File 1993-0085

Name: Retirement Center - Final Plan - SE Corner of 12th St. & F 1/2 Rd.

TITLE HEADING: Subdivision Final Plat; Final Plan,
Lot 1 - The Atrium of Grand Valley

THE ATRIUM OF GRAND VALLEY
Response to Review Comments
re: City of Grand junction Planning Department File No. 85-93

(B) SITE SECTION @ TWO STORY BUILDING

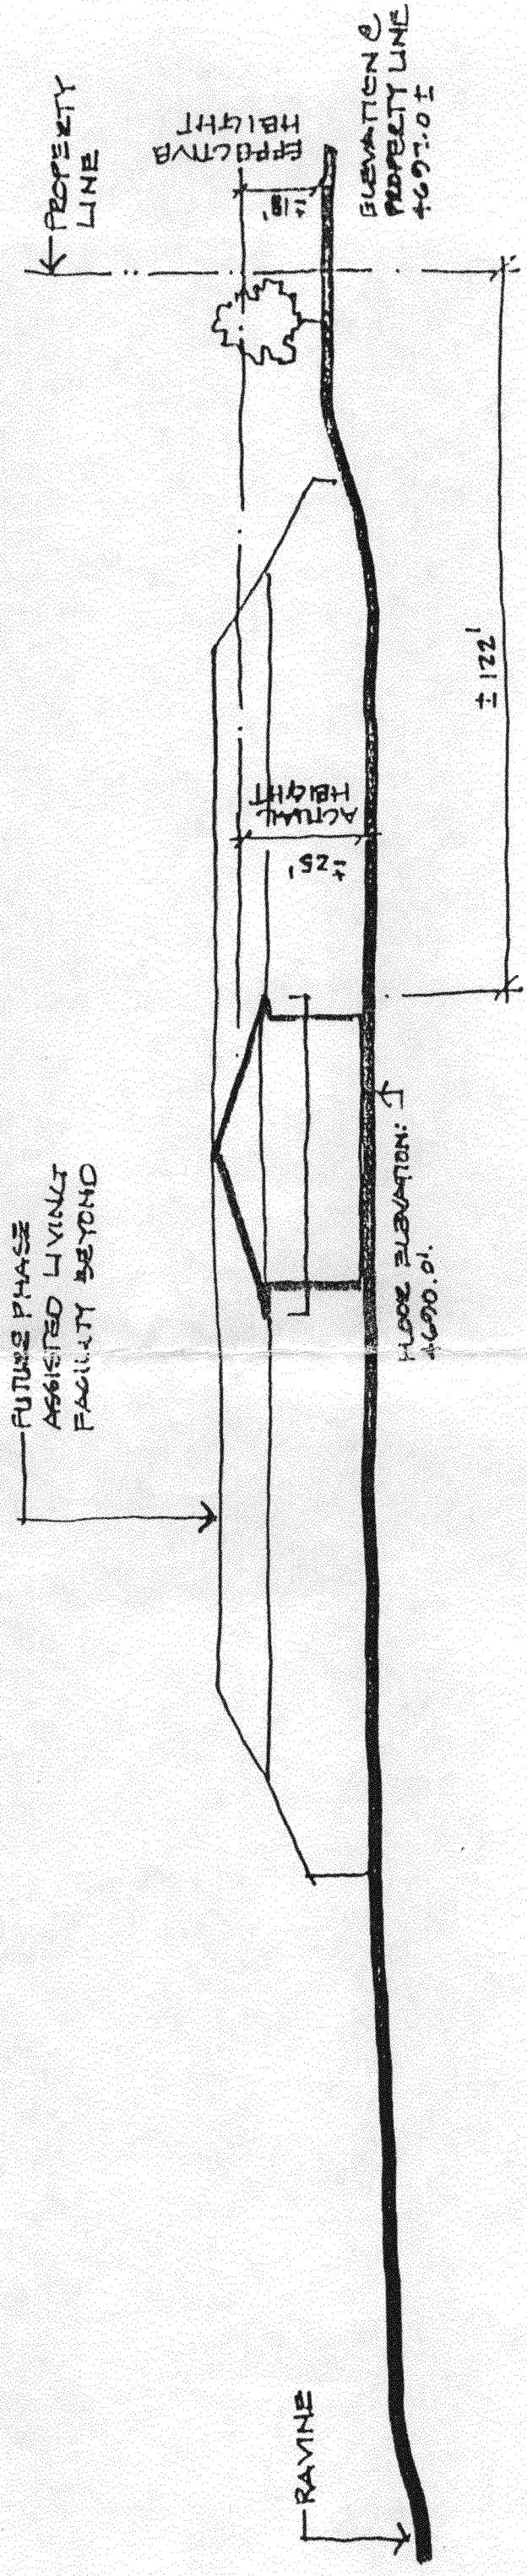
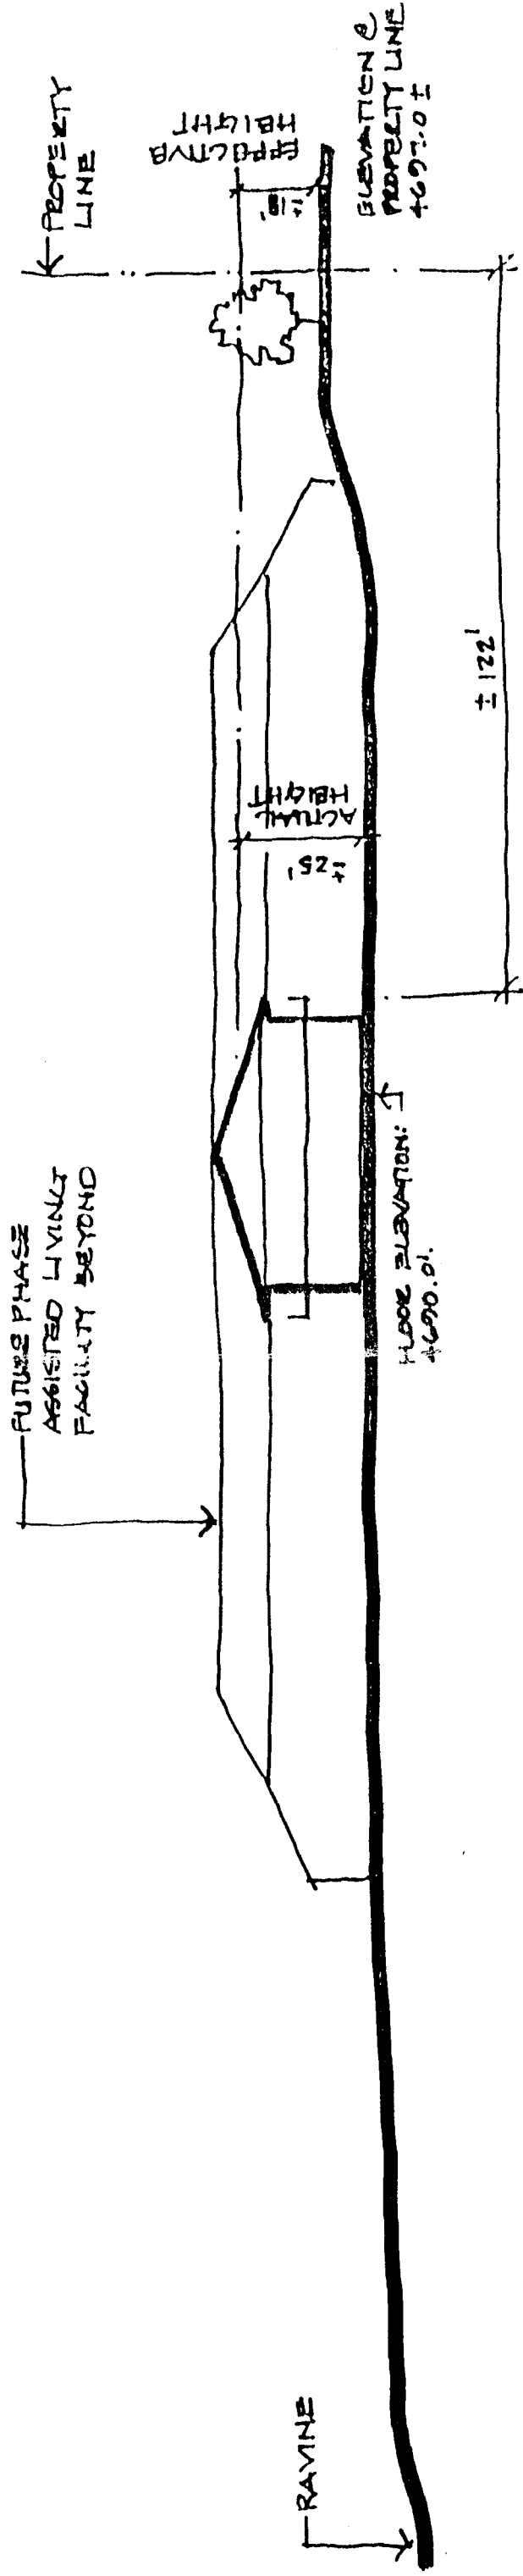
Now refer to the pink page regarding the face of the building. Not just the highest part on the building is in violation of the code, the entire main body of the building is 41 feet 9 inches tall, which exceeds both the residential code and the B1 business transition zone code. I only mention the B1 code to show that this building does not even comply with the next higher code requirement and certainly is a gross violation of the community standard for a residential area.

(A) SITE SECTION @ THREE STORY BUILDING

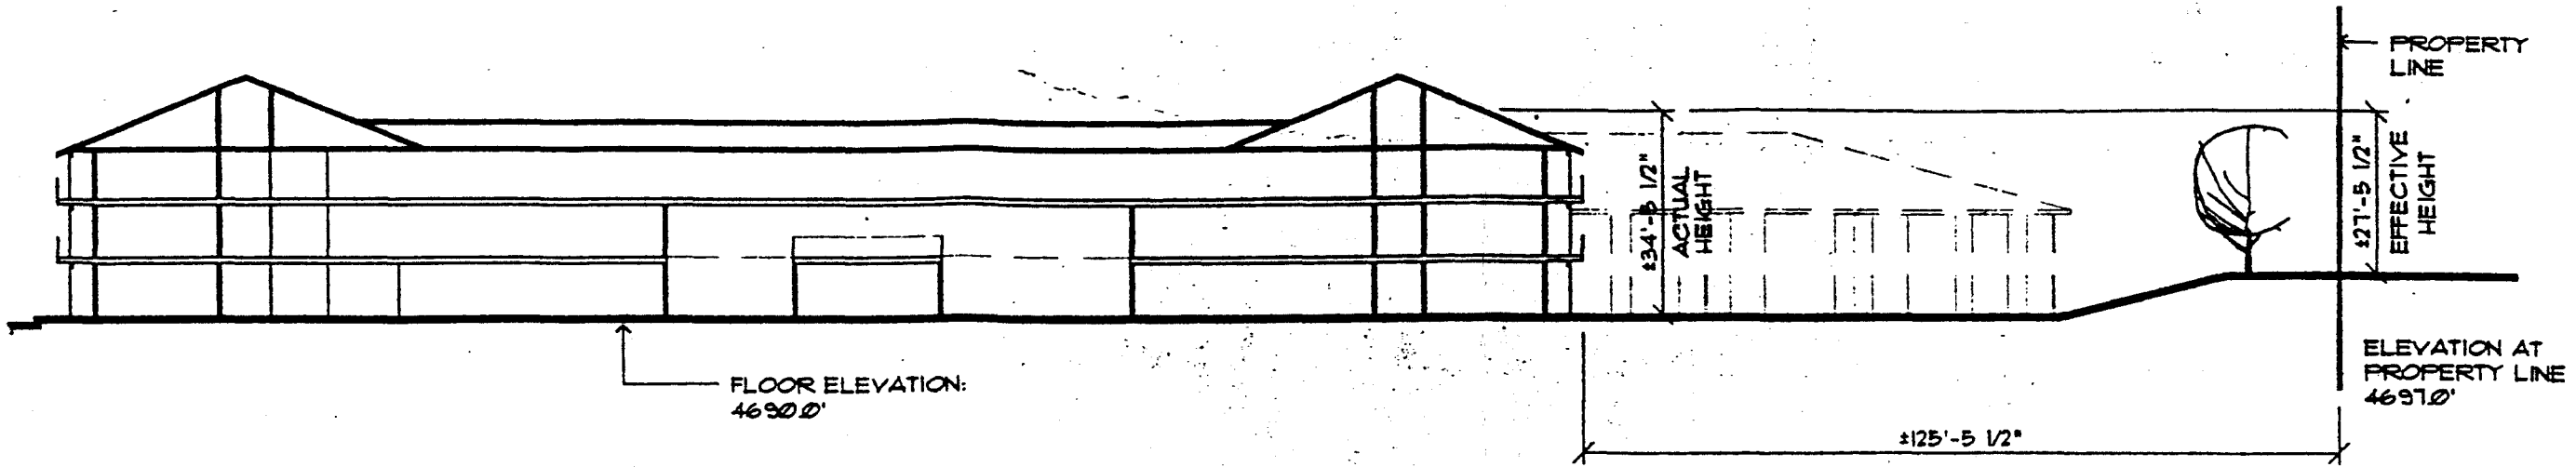
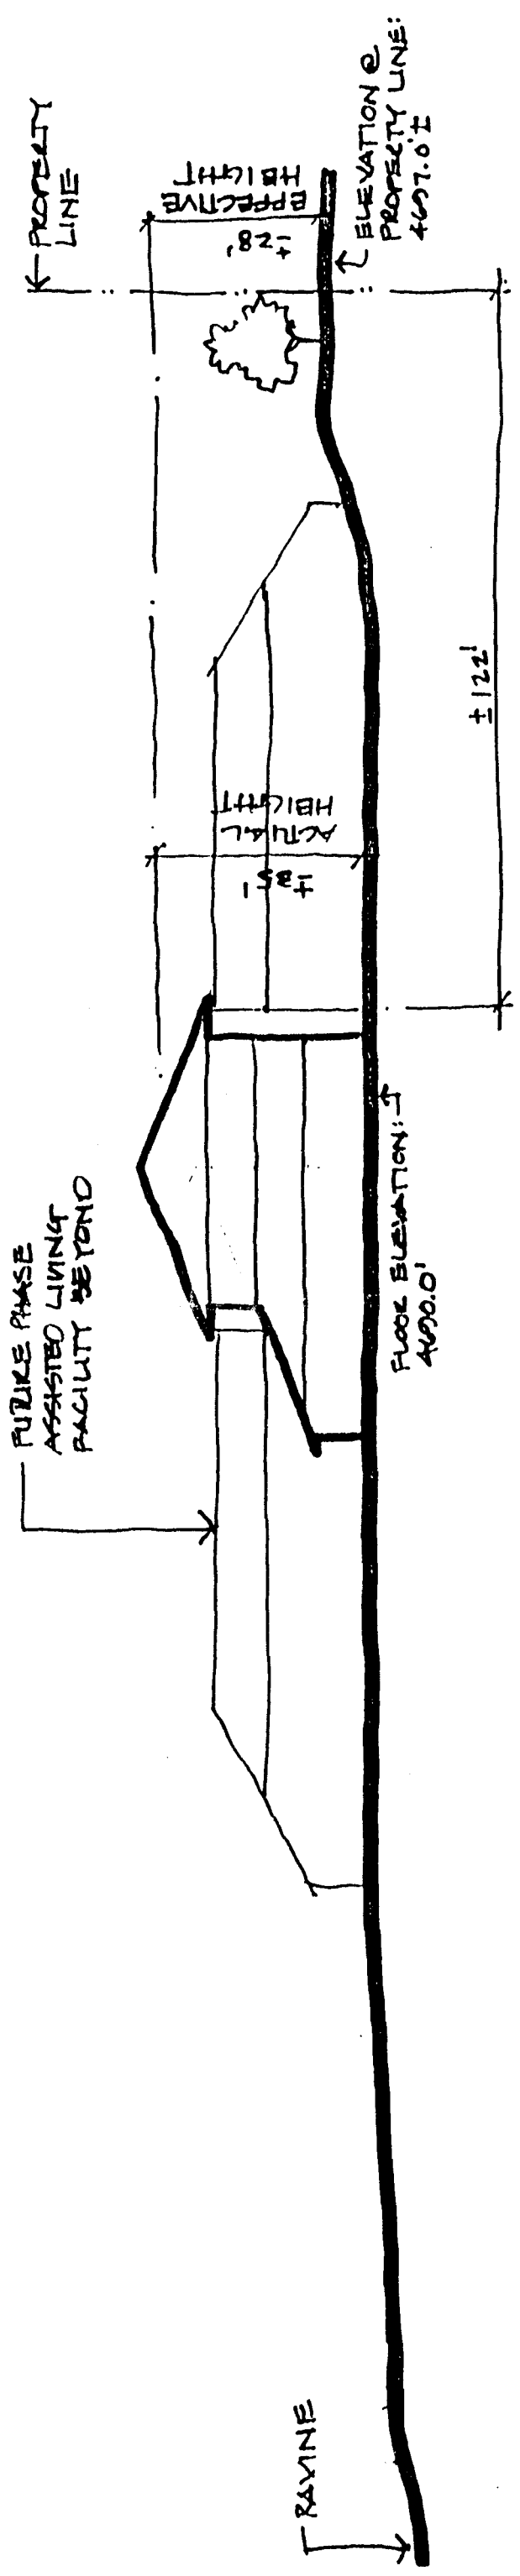
Referring again to the yellow sheets, Site Section A is shown with reference numbers which are not the specification criteria in the Grand Junction Zoning and Development Code. Additionally the preliminary plans for the third floor do not extend onto that wing and therefore any numbers generated from that site must be seriously questioned. They probably do not represent the third story part of the building at all.

Now refer to the Final Plans on the pink page. Site Section A now represents the same cross section appearing to be over 250 feet now. A vast difference from the preliminary 75 foot cross section and not in agreement with the plans at all. Why is this?
